**Addendum 2**  
**Solicitation 23-99776**  
**GANC Connector Trail, Snowmaking & Lighting**

This addendum serves to notify all bidders of the following changes to the solicitation documents:

PROJECT NO. 16585.000  
 DRAWING NO. 25

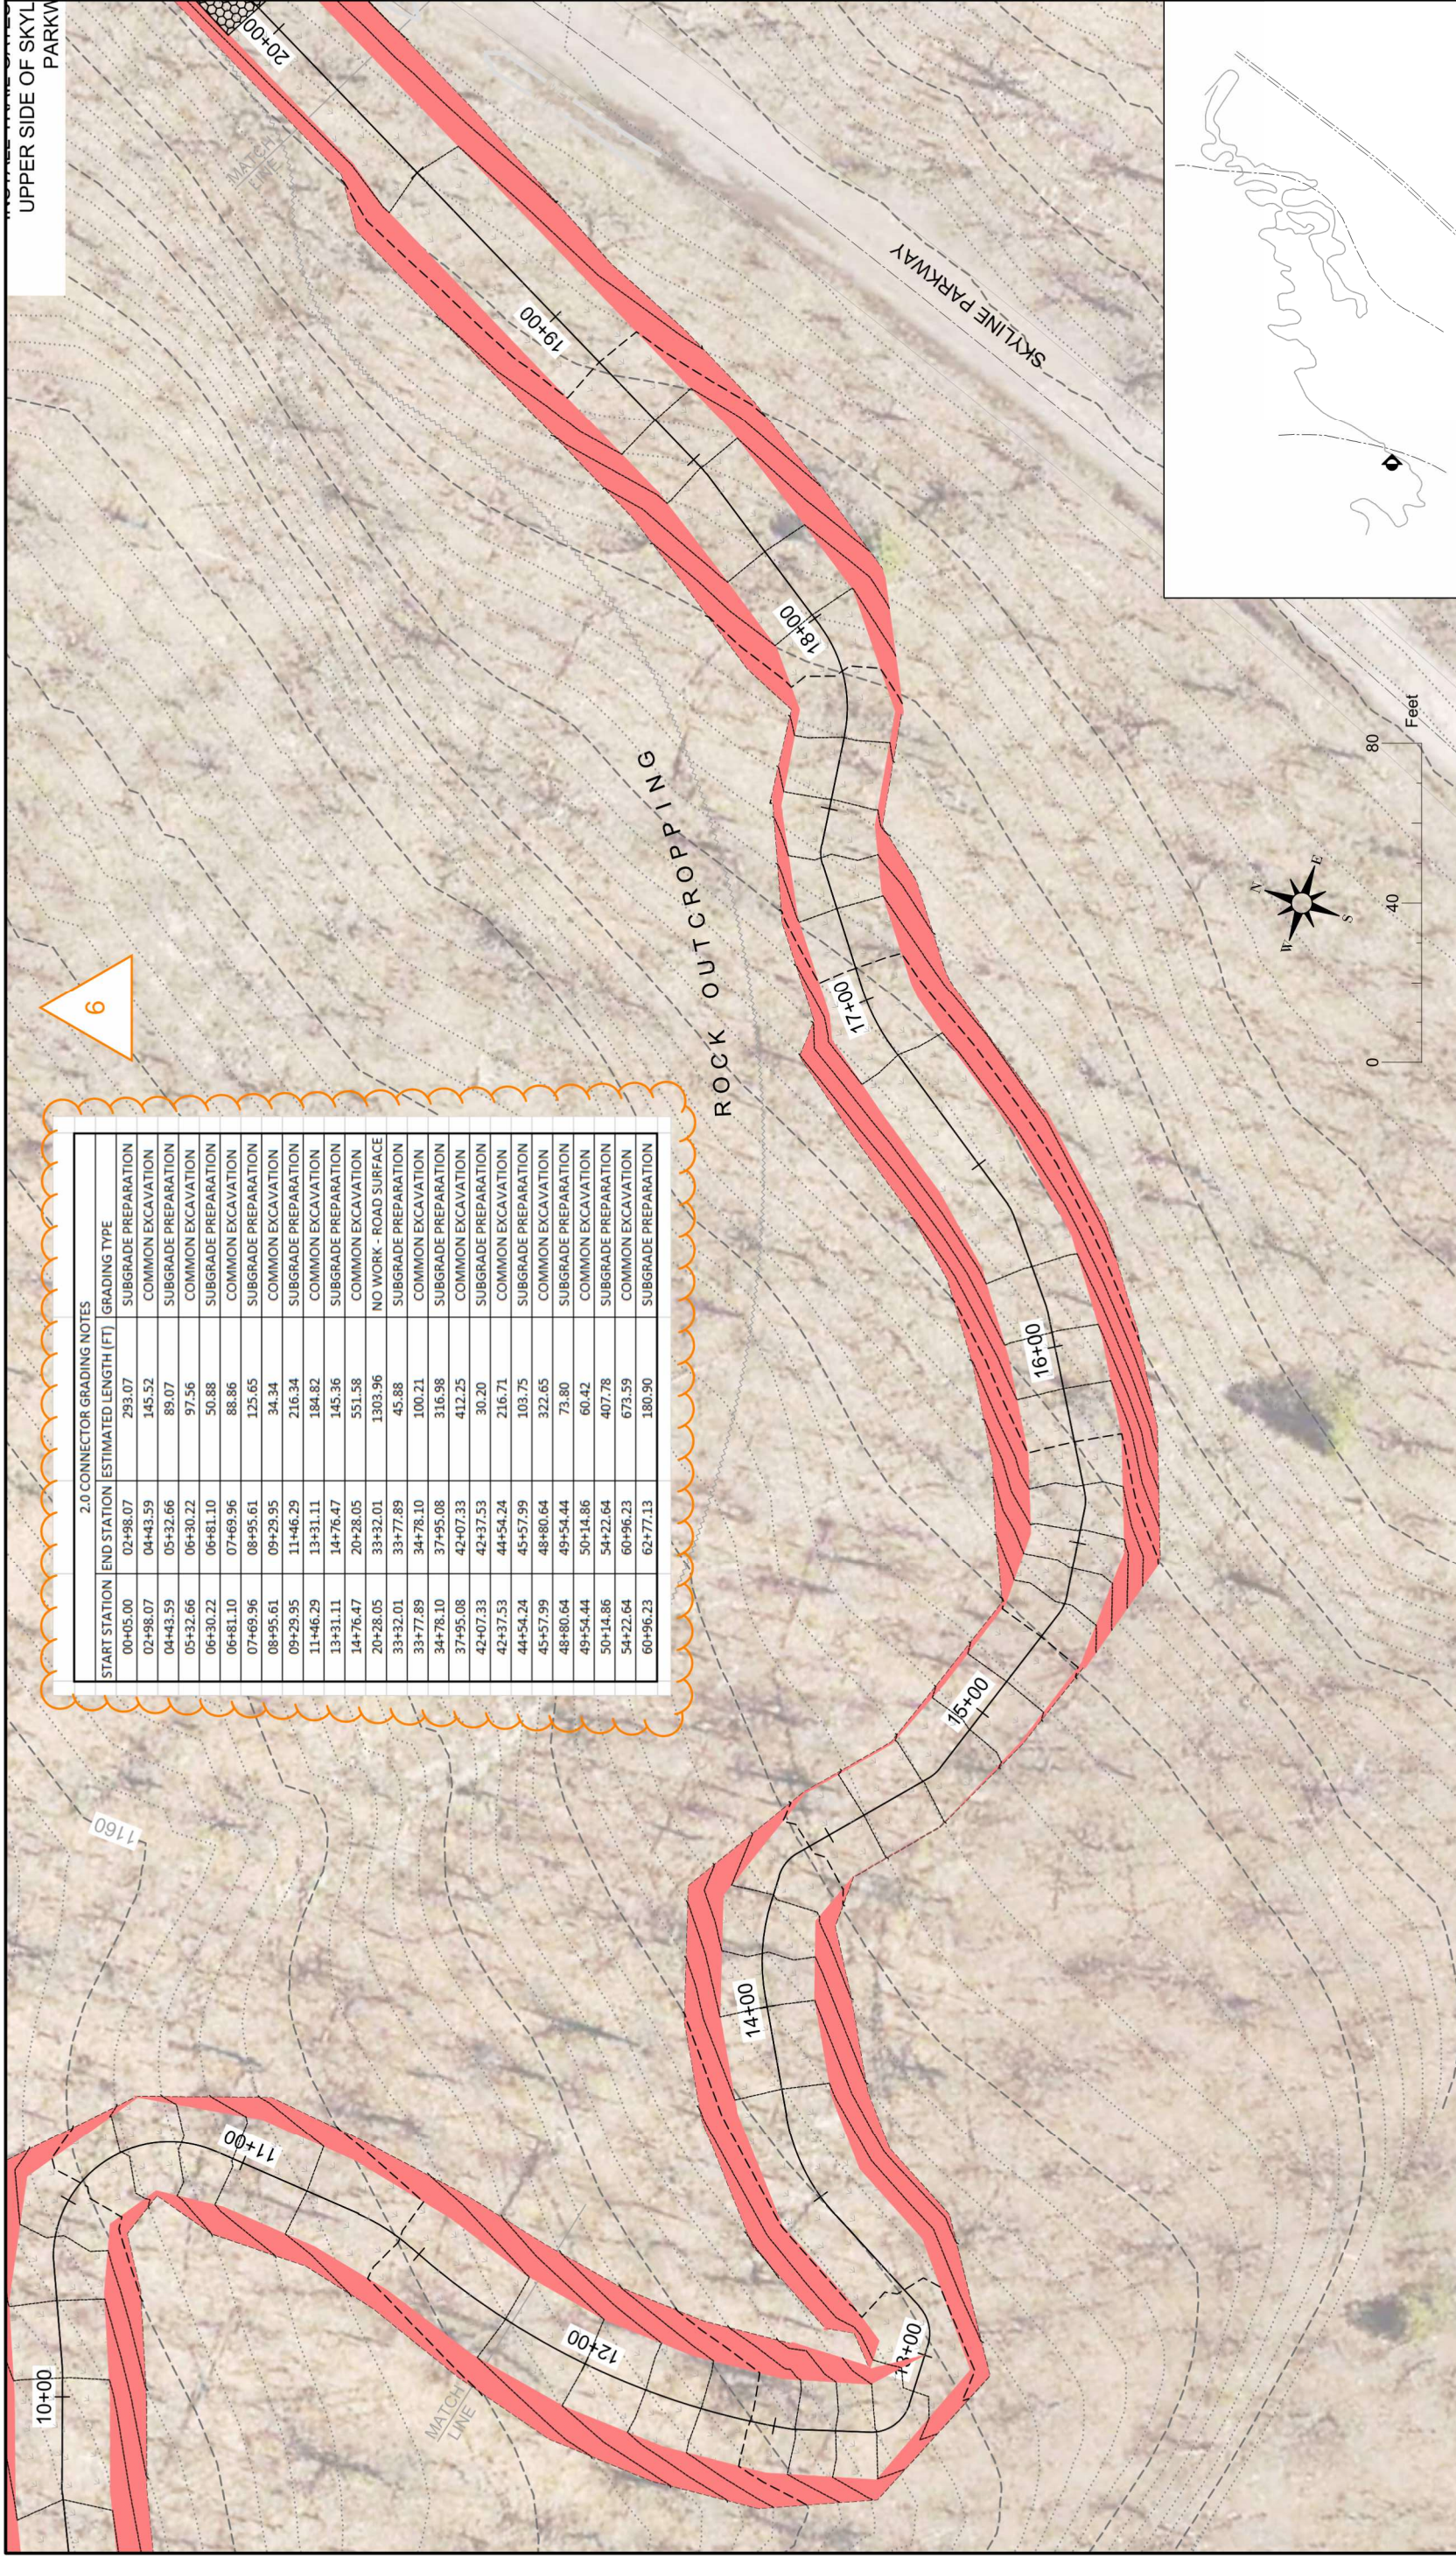
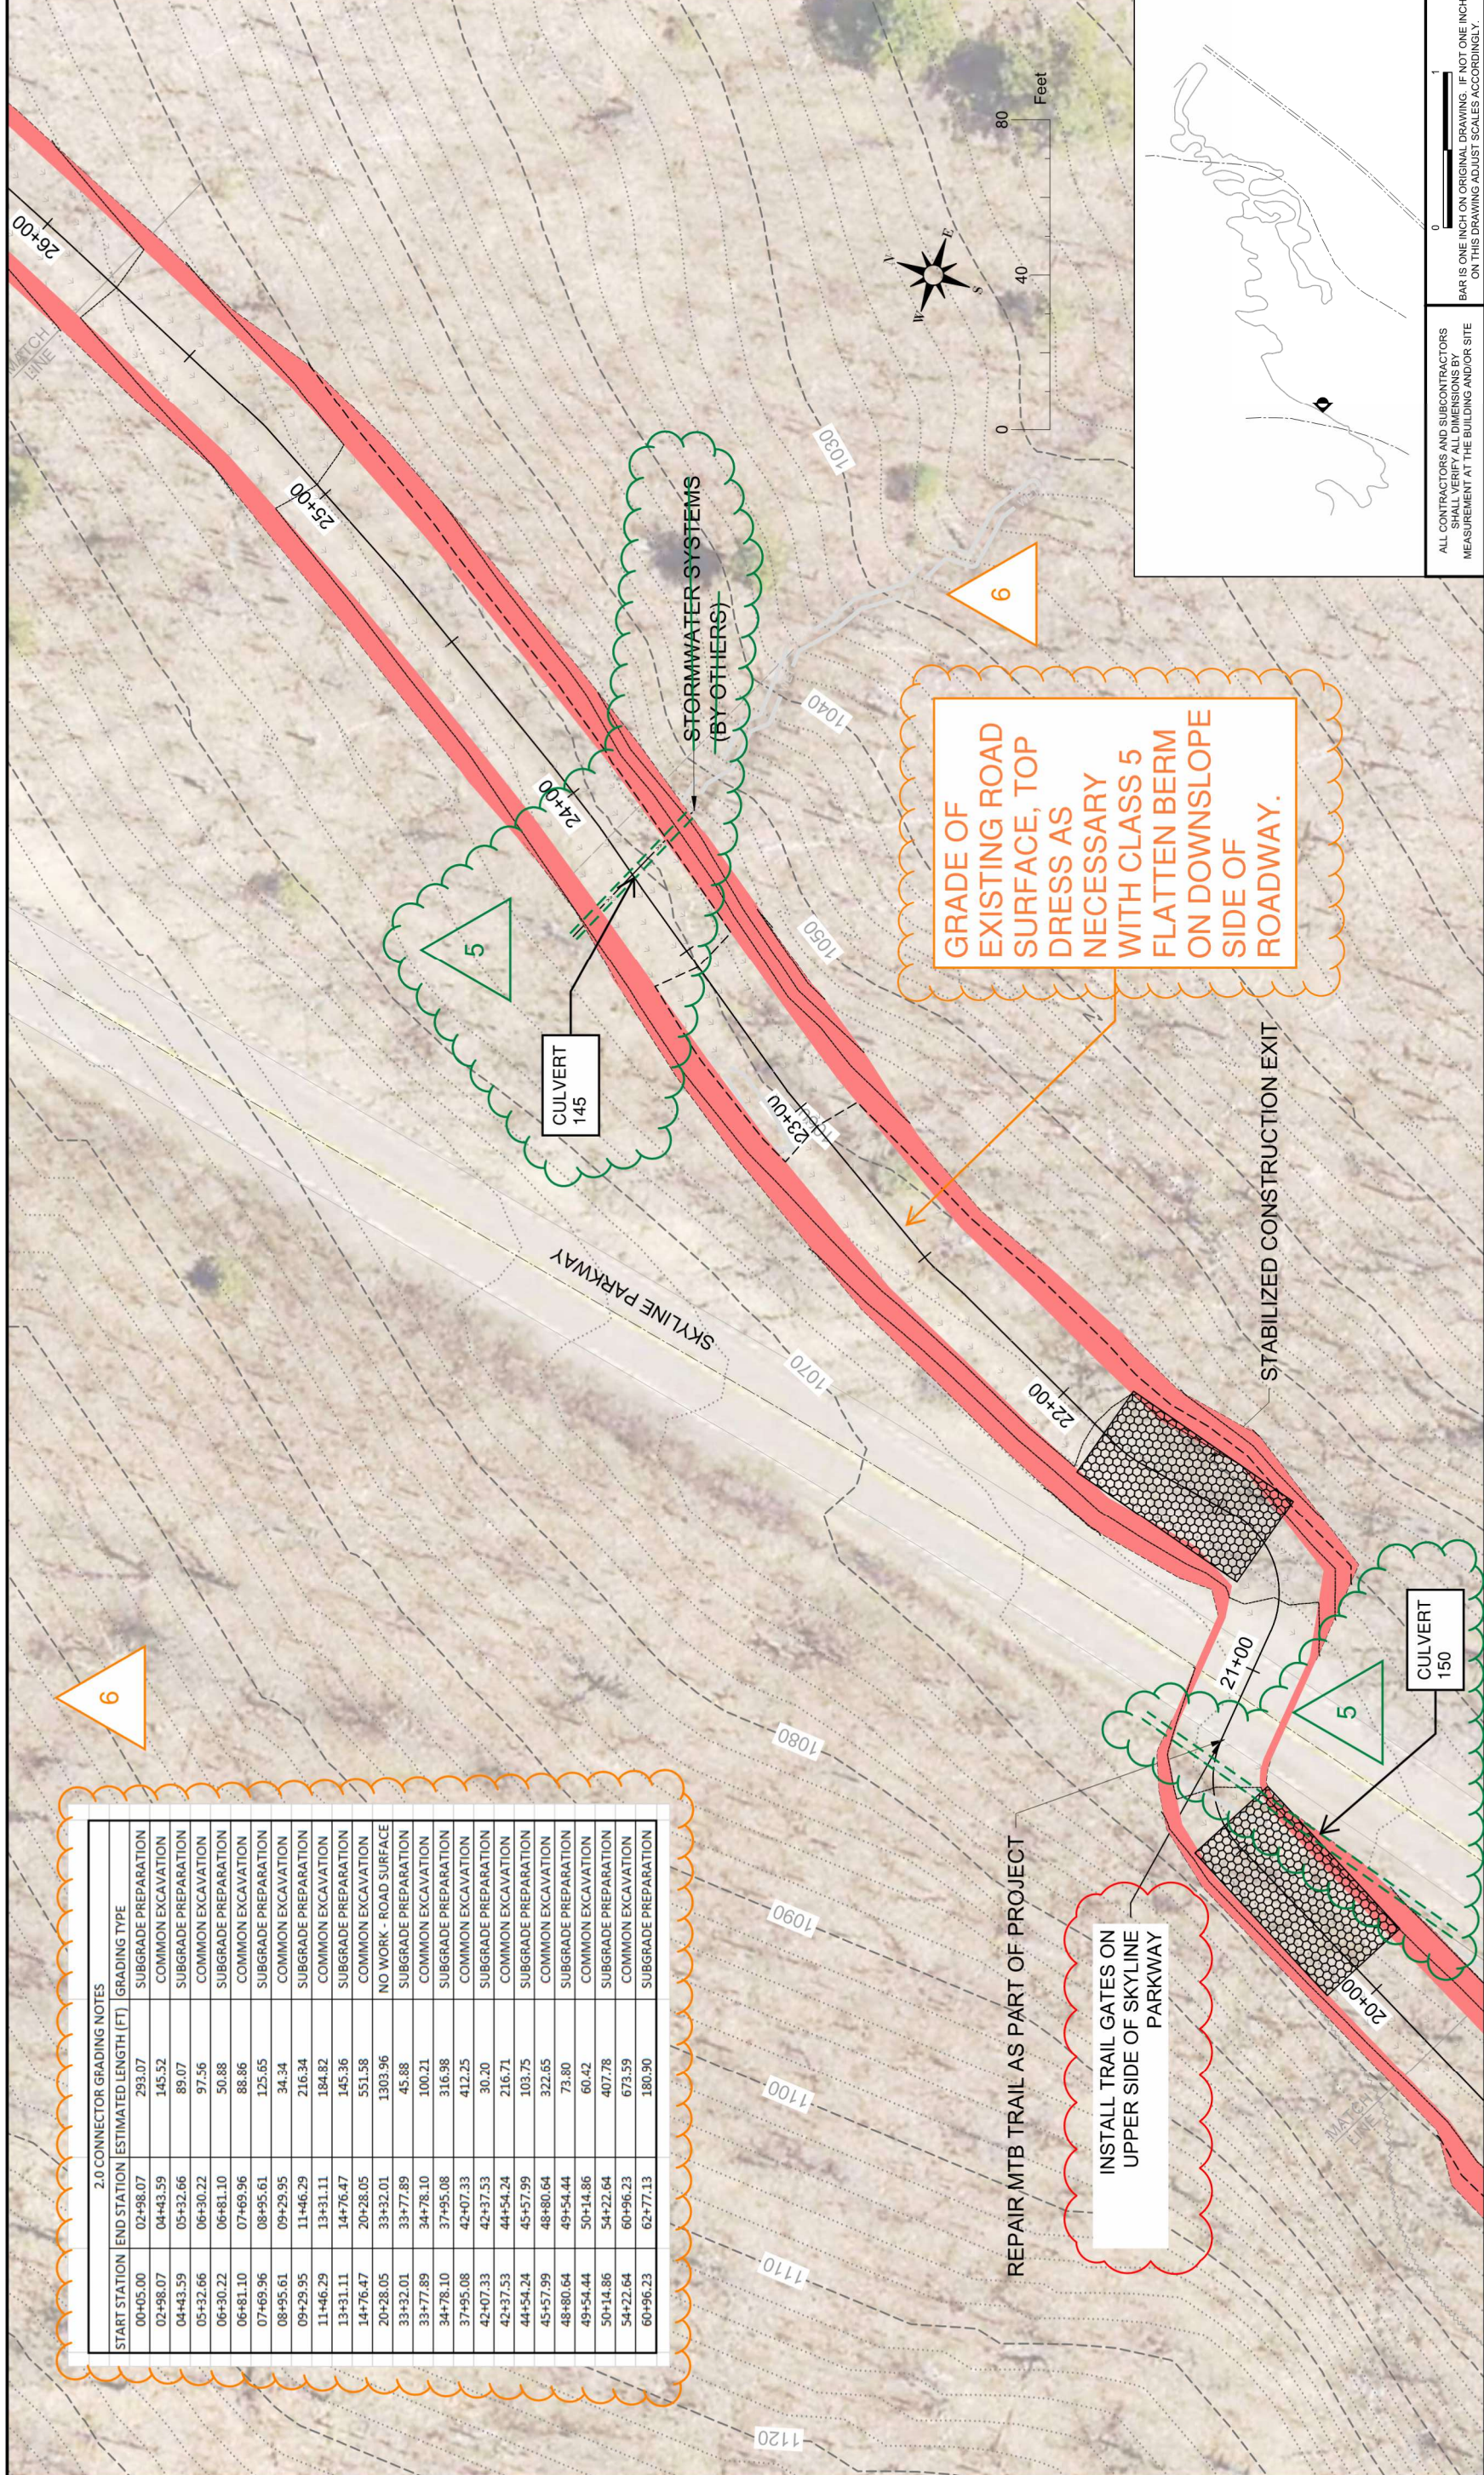
Subgrade Preparation shall consist of removing rocks and stumps within the trail width (24 feet), filling in any holes left behind, and rake area smooth. Contractor shall complete this work in the areas of the 2.0 km Connector trail that are noted as SUBGRADE PREPARATION in the plans.

START STATION	END STATION	ESTIMATED LENGTH (FT)	GRADING TYPE
00+05.00	02+98.07	293.07	SUBGRADE PREPARATION
02+98.07	04+43.59	145.52	COMMON EXCAVATION
04+43.59	05+32.66	89.07	SUBGRADE PREPARATION
05+32.66	06+30.22	97.56	COMMON EXCAVATION
06+30.22	06+81.10	50.88	SUBGRADE PREPARATION
06+81.10	07+69.96	88.86	COMMON EXCAVATION
07+69.96	08+95.61	125.65	SUBGRADE PREPARATION
08+95.61	09+29.95	34.34	COMMON EXCAVATION
09+29.95	11+46.29	216.34	SUBGRADE PREPARATION
11+46.29	13+31.11	184.82	COMMON EXCAVATION
13+31.11	14+76.47	145.36	SUBGRADE PREPARATION
14+76.47	20+28.05	551.58	COMMON EXCAVATION
20+28.05	33+32.01	1303.96	NO WORK - ROAD SURFACE
33+32.01	33+77.89	45.88	SUBGRADE PREPARATION
33+77.89	34+78.10	100.21	COMMON EXCAVATION
34+78.10	37+95.08	316.98	SUBGRADE PREPARATION
37+95.08	42+07.33	412.25	COMMON EXCAVATION
42+07.33	42+37.53	30.20	SUBGRADE PREPARATION
42+37.53	44+54.24	216.71	COMMON EXCAVATION
44+54.24	45+57.99	103.75	SUBGRADE PREPARATION

45+57.99	48+80.64	322.65	COMMON EXCAVATION
48+80.64	49+54.44	73.80	SUBGRADE PREPARATION
49+54.44	50+14.86	60.42	COMMON EXCAVATION
50+14.86	54+22.64	407.78	SUBGRADE PREPARATION
54+22.64	60+96.23	673.59	COMMON EXCAVATION
60+96.23	62+77.13	180.90	SUBGRADE PREPARATION

**1 LIGHTING PLAN**  
1" = 100'-0"

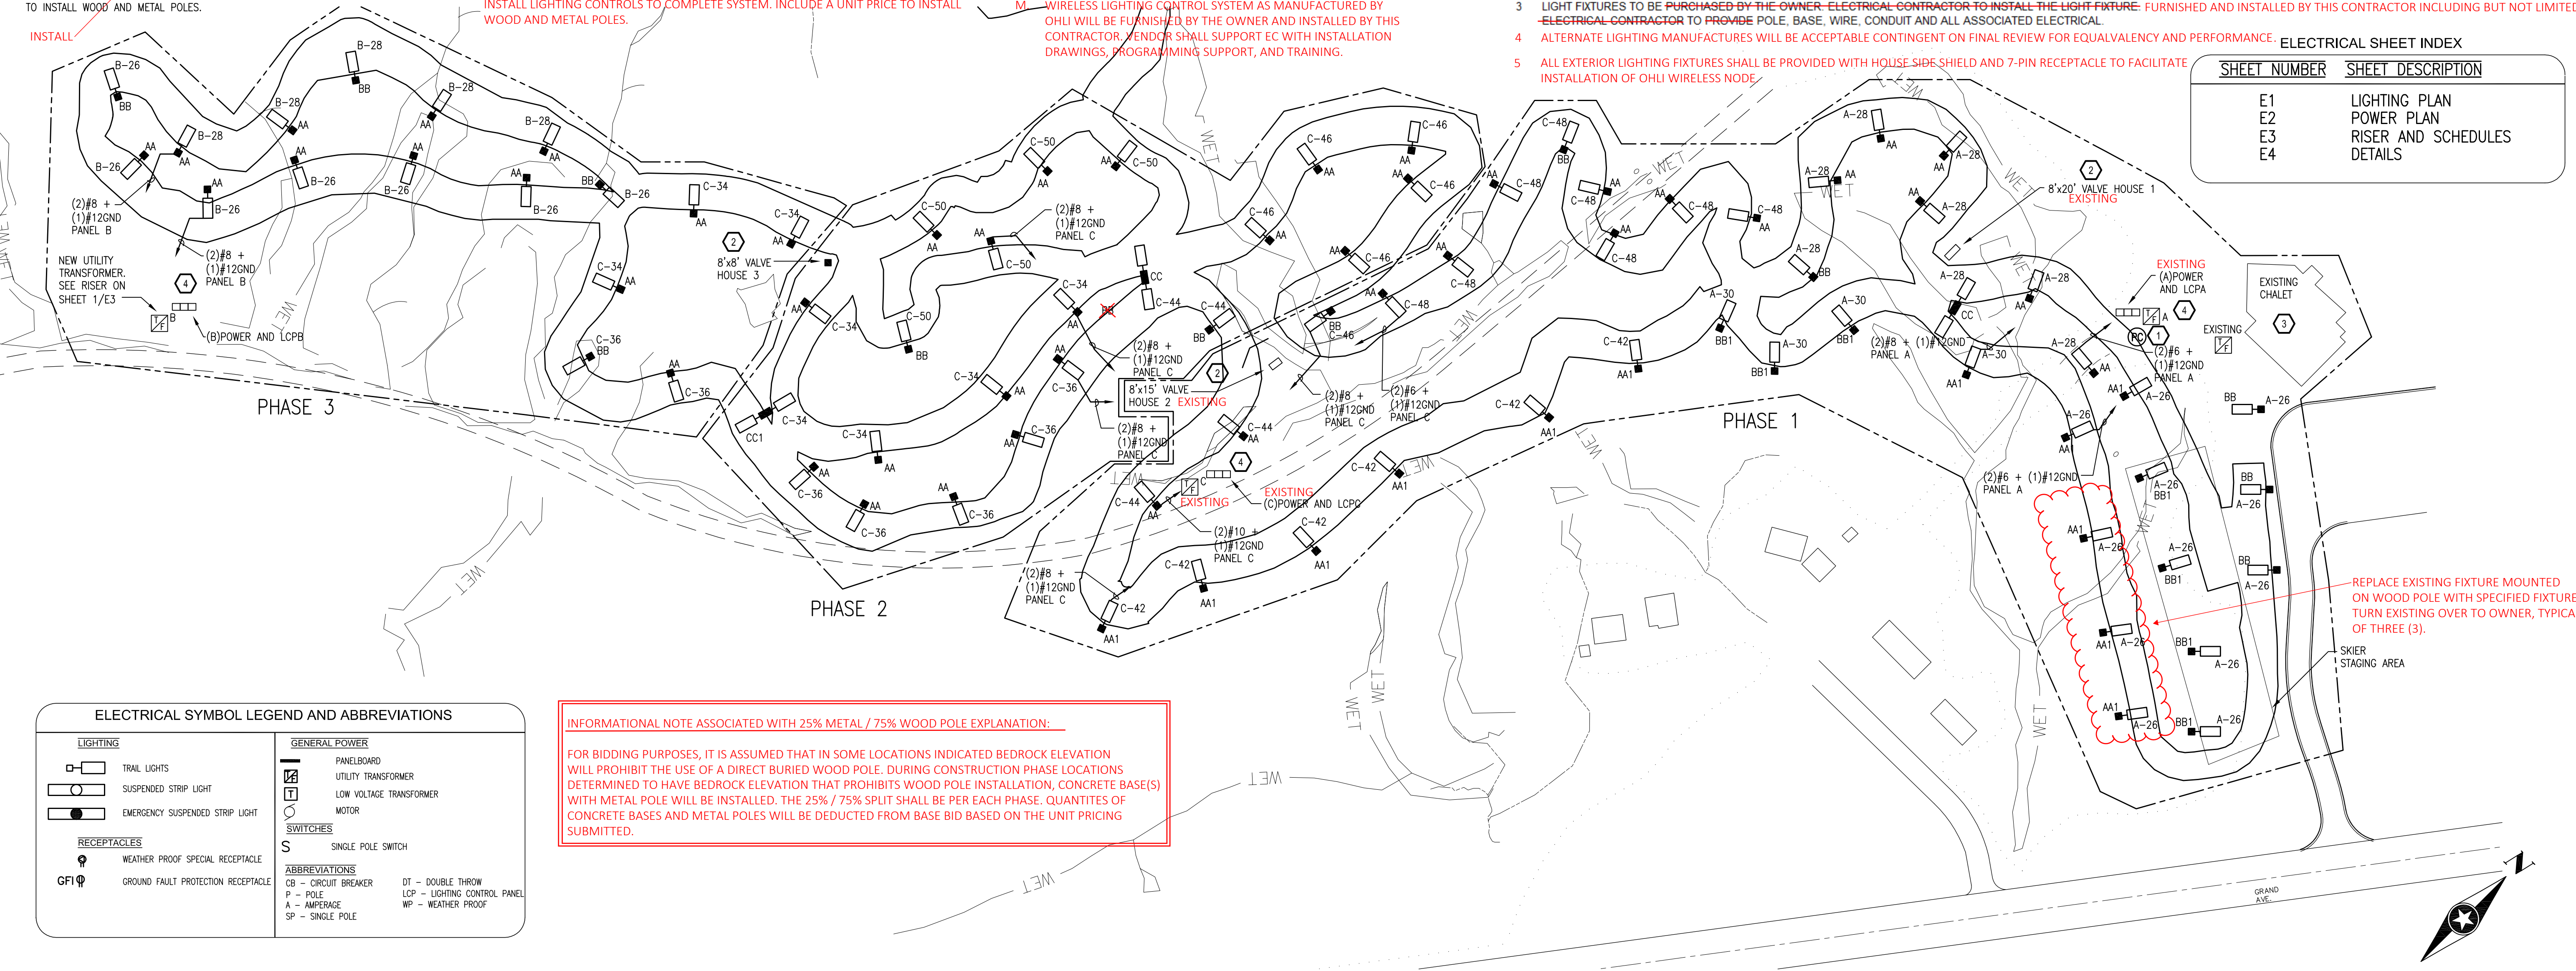
11. On general notes on electrical plans it indicates direct buried MC. Is this for all lighting and power that needs to be trenched? I was told there are some areas that cannot be trenched. If so, do you want to change to pipe and wire for that, so its protected?

- a. Yes. See Addendum 2 (11/30/23).
12. Light fixtures are provided by owner does this include hardware to attach to poles?
  - a. Contractor to provide hardware. See item 1 above. See Addendum 2 (11/30/23).

- EC TO PROVIDE NECESSARY HARDWARE FOR MOUNTING. BOLT FIXTURE TO WOOD POLE USING BOLTS THAT GO THROUGH THE POLE WITH WASHERS AND NUTS. DO NOT USE LAG BOLTS. FOR THE TOTAL AMOUNT OF POLES IN THE PROJECT, PROVIDE 75% TO BE WOOD UTILITY POLES. SEE DETAIL ON SHEET 3/E4.

- EC TO PROVIDE NECESSARY HARDWARE FOR MOUNTING. FOR THE TOTAL AMOUNT OF POLES IN THE PROJECT, PROVIDE 25% OF THE POLES TO BE METAL. SEE DETAIL ON SHEET 1/E4.
